**10% PRELIMINARY
DESIGN STUDY**

SOCALGAS PRELIMINARY PROJECT SCOPE FOR A NEW 66/4 KV SUBSTATION

**CUSTOMER - DEDICATED SUBSTATION
PLOT PLAN-(2) 66KV LINE SERVICES WITH
(1) TRANSFORMER BANK**

Overview for Options 1 and 2

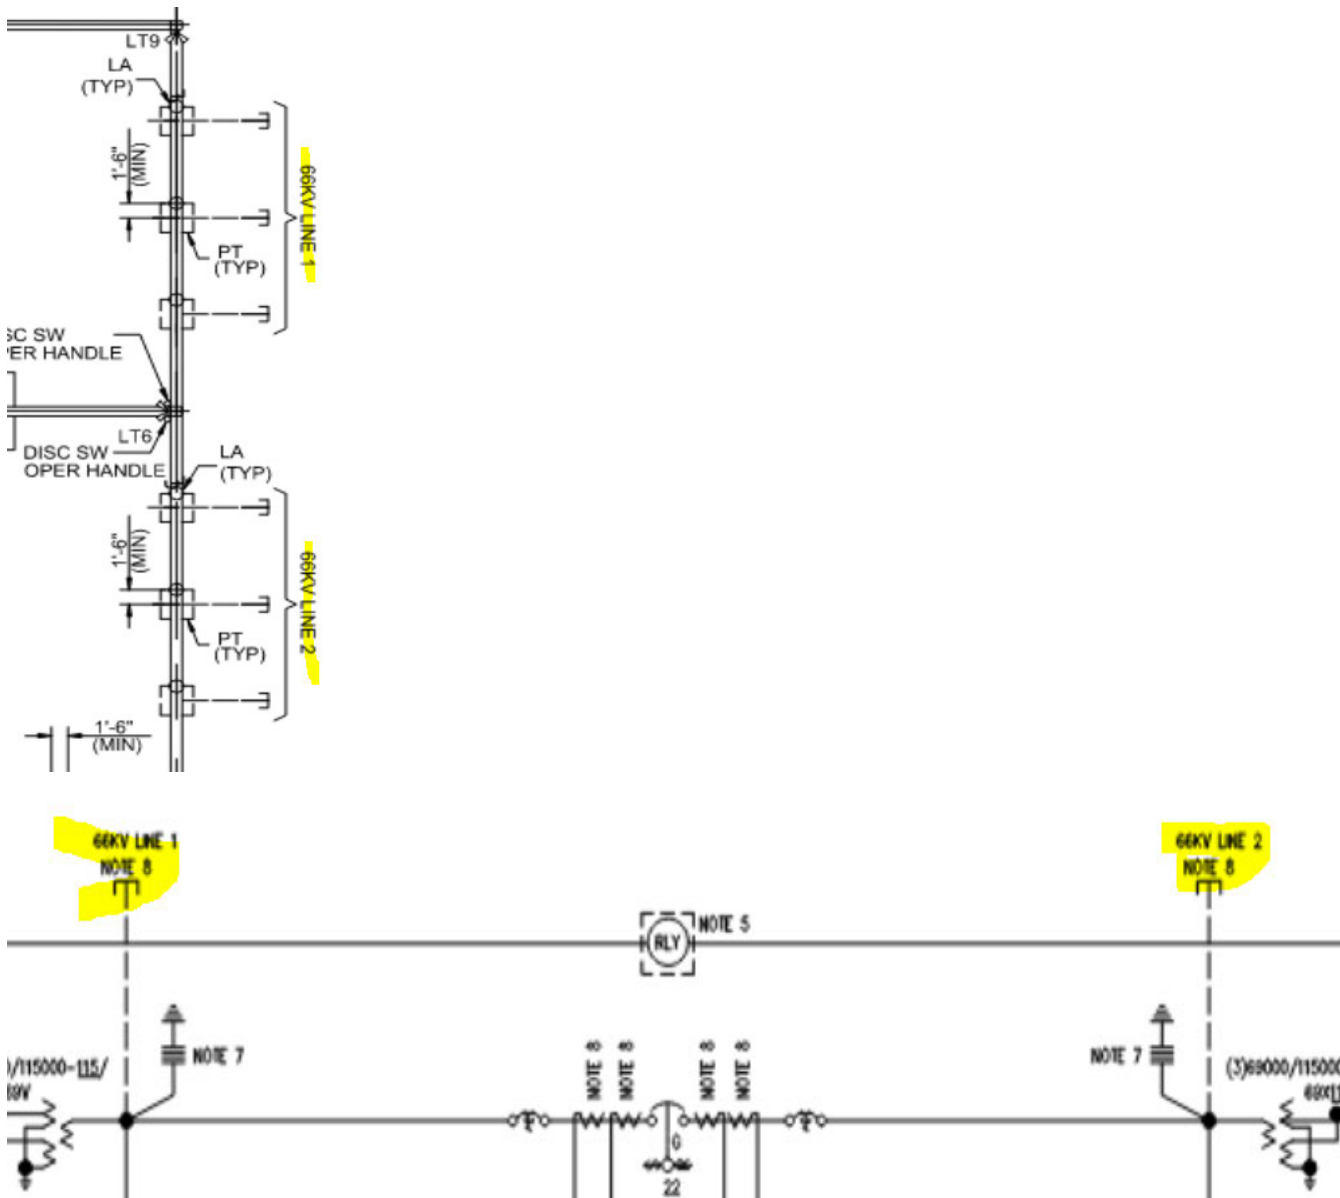
1. Where is 2nd 66kV feed from SCE on the single line? [Response: Please refer to Option 2 \(One Line, Plot Plan, and Scope Document \)](#)

2. Why are there 3 circuit breakers? **Response:** The partial ring bus configuration is an extension of the sectionalized bus arrangement and is accomplished by interconnecting the two open ends of the buses through another sectionalizing breaker. This results in a closed loop or ring with each bus section separated by a circuit breaker. For maximum reliability and operation flexibility – for a breaker failure, the two breakers on the sides of the affected breaker open, along with a transfer trip to a remote breaker, to isolate the failed breaker and remove two bus sections from service. The ring bus arrangement provides for circuit breaker maintenance since any breaker can normally be removed from service without interruption of services to any circuits. Similar situation for Option 2 bus arrangement by showing four (4) circuit positions which is a practical maximum for a ring bus configuration.

3. Where are the other 4kV feed lines for the other two EDCs? (all electric option) **Response:** Option 1 shows two (2) 4 kV Feeders as requested, and Option 2 shows an additional two (2) more 4 kV Feeders for future loads.

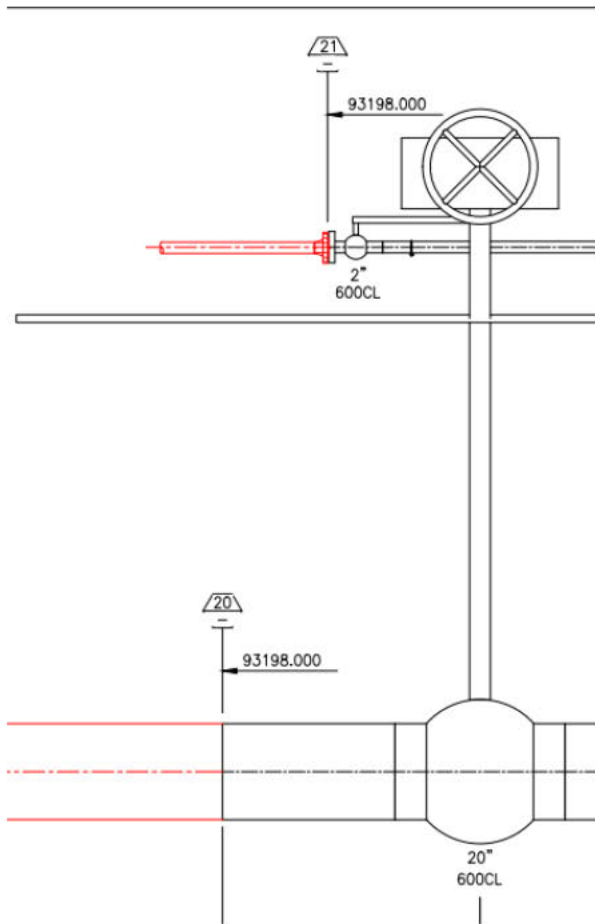
We have completed our review of the drafts shared and below are the requested modifications:

1. Please edit the title block to state "Proposed Gas Pipeline Tie-ins Drawing"
2. Add the word "new" ahead of the suction and discharge tie-ins shown below

3. Use blue color to all the gas pipelines within the drawing to allow the new layer to be better distinguishable
4. Add a description to the depressurization line denoting "depressurization tie-in to Line 1003" where it meets L1003
5. Add a table on the right hand side of page 1906 to contain the estimated excavation volumes for each of the suction line, discharge lines, fuel gas lines and depressurization to Line 1003. The table is to contain the following columns: location description (line names referenced in the drawing next to the description), diameter, segment length, estimated excavation volume in cubic feet.
6. Make sure there is a legend on the drawing to state the dashed lines are underground pipelines and the solid lines are above grade.
7. Add a note on page 1907 to the demarcation points 20 and 21 to state "installed by others" as shown below:

Overview for Options 1 and 2

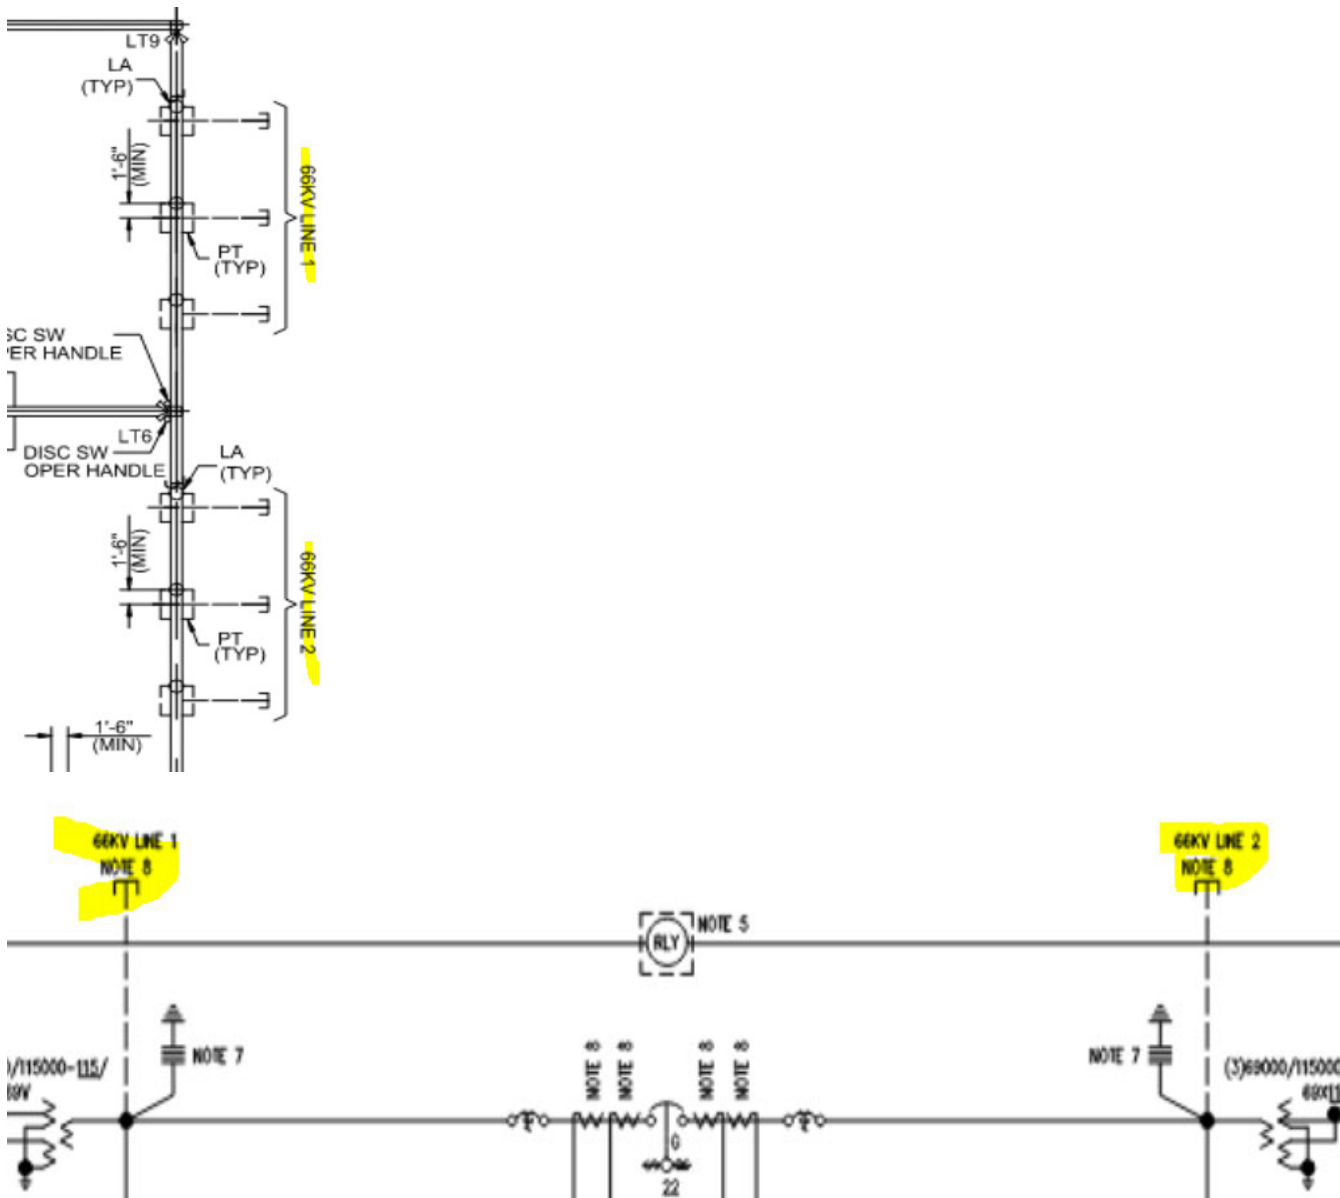
1. Where is 2nd 66kV feed from SCE on the single line? [Response: Please refer to Option 2 \(One Line, Plot Plan, and Scope Document \)](#)

2. Why are there 3 circuit breakers? **Response:** The partial ring bus configuration is an extension of the sectionalized bus arrangement and is accomplished by interconnecting the two open ends of the buses through another sectionalizing breaker. This results in a closed loop or ring with each bus section separated by a circuit breaker. For maximum reliability and operation flexibility – for a breaker failure, the two breakers on the sides of the affected breaker open, along with a transfer trip to a remote breaker, to isolate the failed breaker and remove two bus sections from service. The ring bus arrangement provides for circuit breaker maintenance since any breaker can normally be removed from service without interruption of services to any circuits. Similar situation for Option 2 bus arrangement by showing four (4) circuit positions which is a practical maximum for a ring bus configuration.

3. Where are the other 4kV feed lines for the other two EDCs? (all electric option) **Response:** Option 1 shows two (2) 4 kV Feeders as requested, and Option 2 shows an additional two (2) more 4 kV Feeders for future loads.

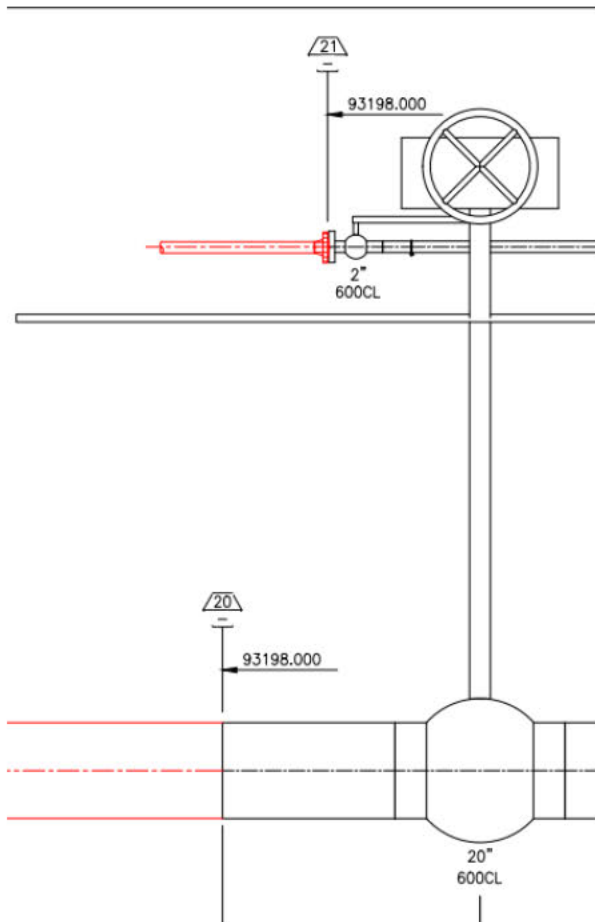
We have completed our review of the drafts shared and below are the requested modifications:

1. Please edit the title block to state "Proposed Gas Pipeline Tie-ins Drawing"
2. Add the word "new" ahead of the suction and discharge tie-ins shown below

3. Use blue color to all the gas pipelines within the drawing to allow the new layer to be better distinguishable
4. Add a description to the depressurization line denoting "depressurization tie-in to Line 1003" where it meets L1003
5. Add a table on the right hand side of page 1906 to contain the estimated excavation volumes for each of the suction line, discharge lines, fuel gas lines and depressurization to Line 1003. The table is to contain the following columns: location description (line names referenced in the drawing next to the description), diameter, segment length, estimated excavation volume in cubic feet.
6. Make sure there is a legend on the drawing to state the dashed lines are underground pipelines and the solid lines are above grade.
7. Add a note on page 1907 to the demarcation points 20 and 21 to state "installed by others" as shown below:

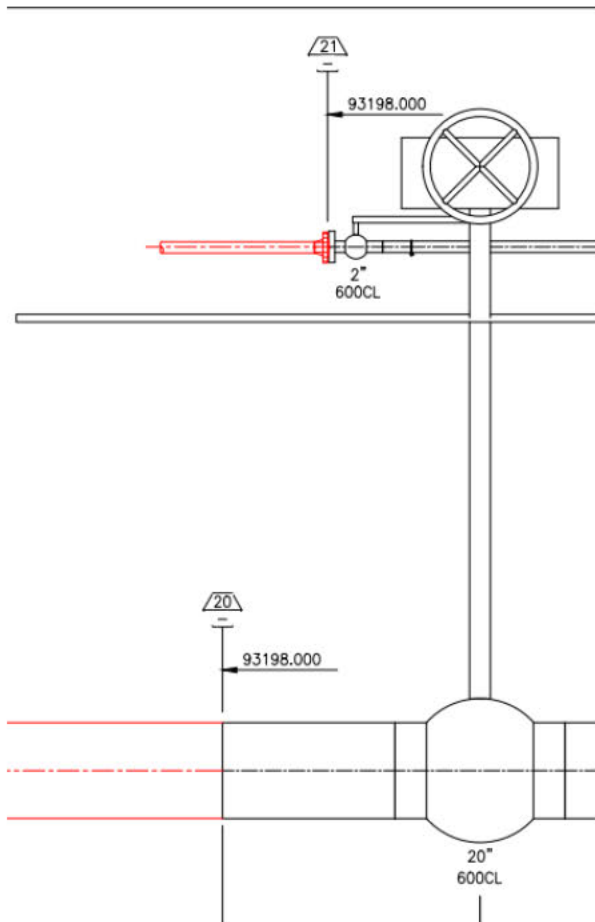
We have completed our review of the drafts shared and below are the requested modifications:

1. Please edit the title block to state "Proposed Gas Pipeline Tie-ins Drawing"
2. Add the word "new" ahead of the suction and discharge tie-ins shown below

3. Use blue color to all the gas pipelines within the drawing to allow the new layer to be better distinguishable
4. Add a description to the depressurization line denoting "depressurization tie-in to Line 1003" where it meets L1003
5. Add a table on the right hand side of page 1906 to contain the estimated excavation volumes for each of the suction line, discharge lines, fuel gas lines and depressurization to Line 1003. The table is to contain the following columns: location description (line names referenced in the drawing next to the description), diameter, segment length, estimated excavation volume in cubic feet.
6. Make sure there is a legend on the drawing to state the dashed lines are underground pipelines and the solid lines are above grade.
7. Add a note on page 1907 to the demarcation points 20 and 21 to state "installed by others" as shown below:
